Metropolitan Development Commission Plat Committee (March 13, 2024) Meeting Agenda

Notice is hereby given that the Plat Committee of the Metropolitan Development Commission of Marion County, IN will hold public hearings on:

Date: Wednesday, March 13, 2024 **Time:** 1:00 PM

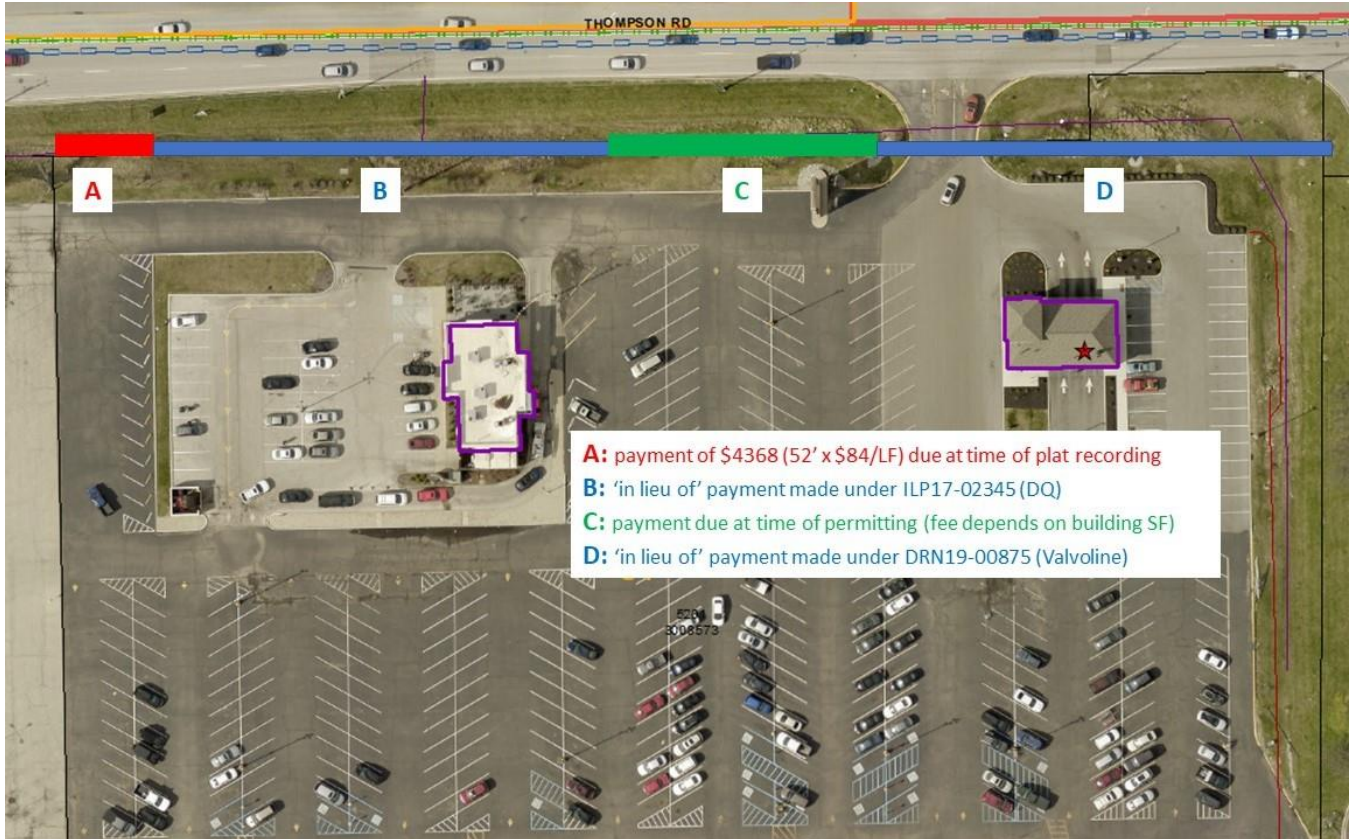
Current topography and drainage along Thompson Road would not make installation of a sidewalk feasible.

The existing shopping center and adjoining shopping centers do not have pedestrian connectivity to the subject property or right-of-way.

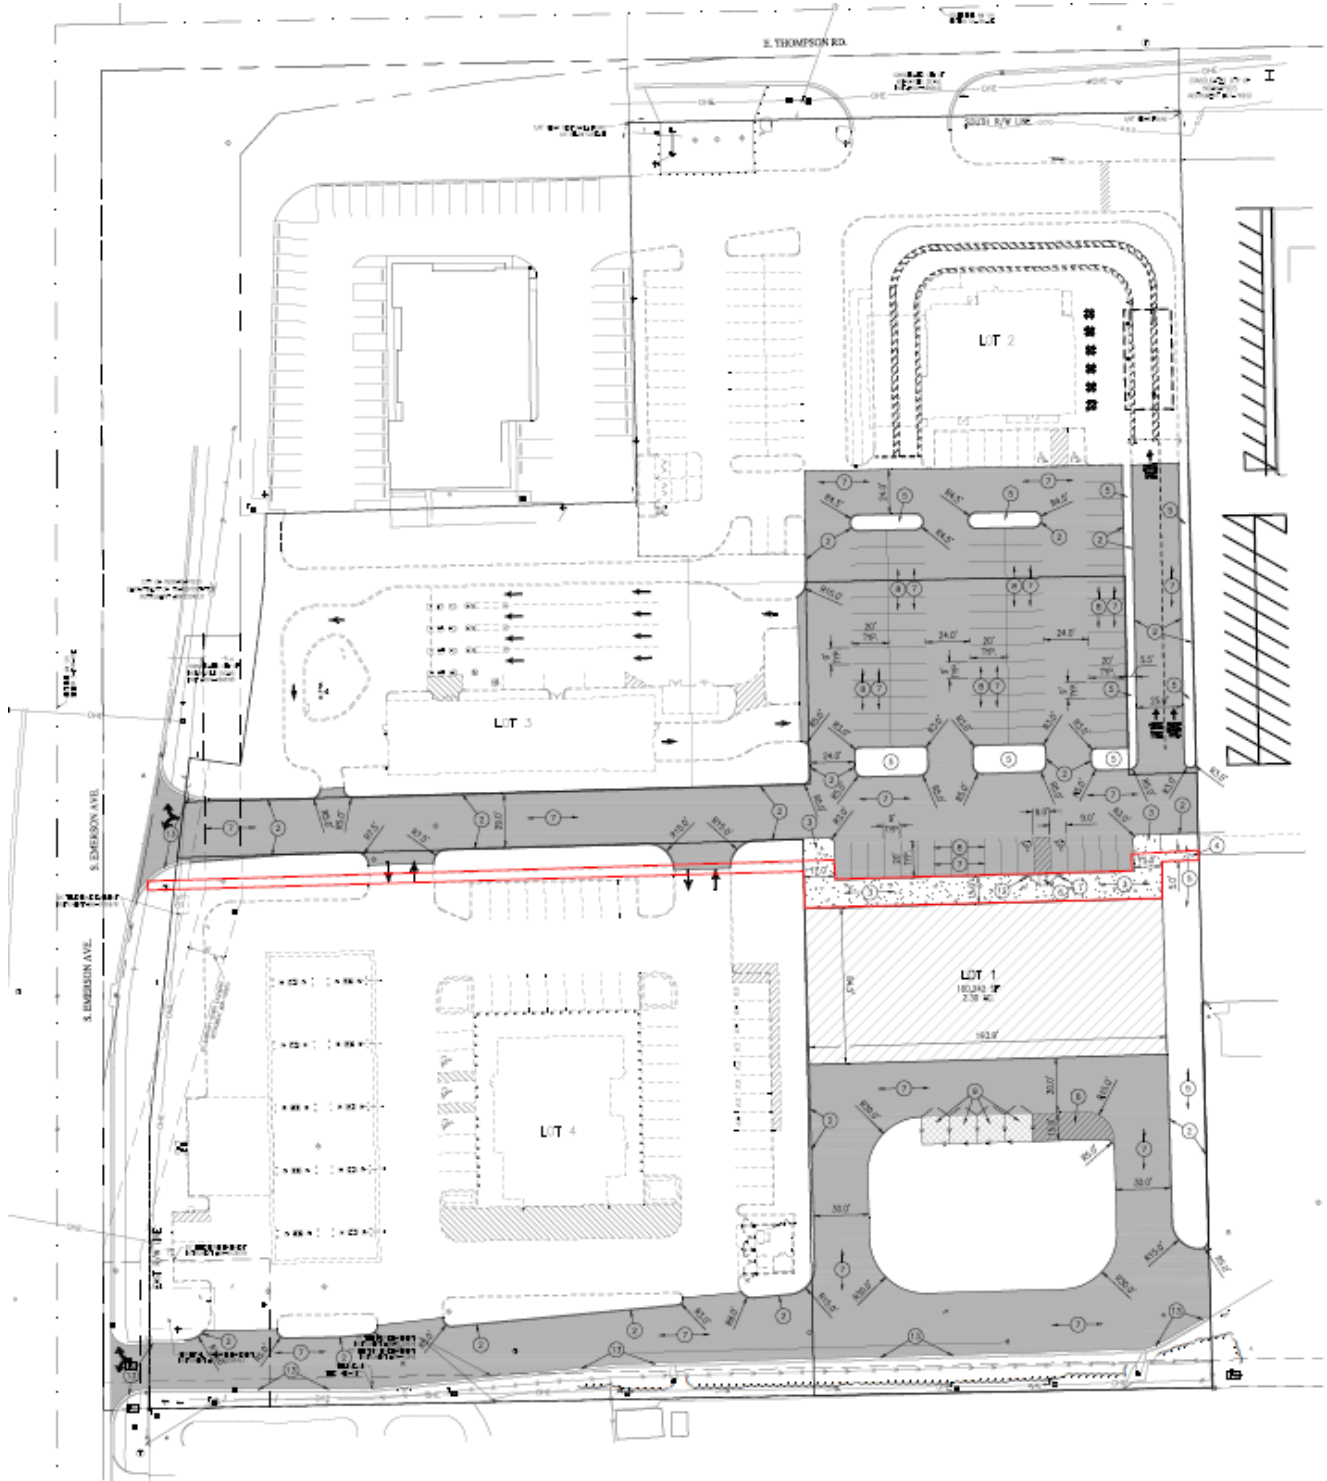
There is currently existing sidewalk along both sides of Emerson Avenue. Sidewalks would be required along Thompson Road (approximately 300' in total length). There is not currently existing pedestrian connectivity servicing the existing multitenant commercial center on either side of Thompson Road, and the applicant claims that the existing drainage ditch and utility site along Thompson would not make installation of sidewalks feasible. Provided findings of fact also indicate that a pathway would be installed through the center of the property to provide internal connectivity (see layout in Exhibits).

Evidence has not been provided to substantiate the claim that any added costs of sidewalk installation near a drainage ditch would outweigh the positive benefits of pedestrian connectivity recommended by comprehensive plans and required by ordinance. Staff would recommend denial of the waiver request. If the plat committee approves the waiver against staff's recommendation, a contribution in lieu of sidewalk installation should be required as a condition of approval subject to Section 744-301.G.

The side ditch of Thompson Road along the south side is a large drainage conveyance that would be negatively impacted by the addition of a pathway.
There are obstructions along the frontage that would prohibit the path, and block its use.

An internal pathway is planned for the BT Indianapolis development that would connect the sidewalk from Emerson all the way to the east side of the BT Indianapolis development to connect to the Emersonn Plaza 2 infrastructure.
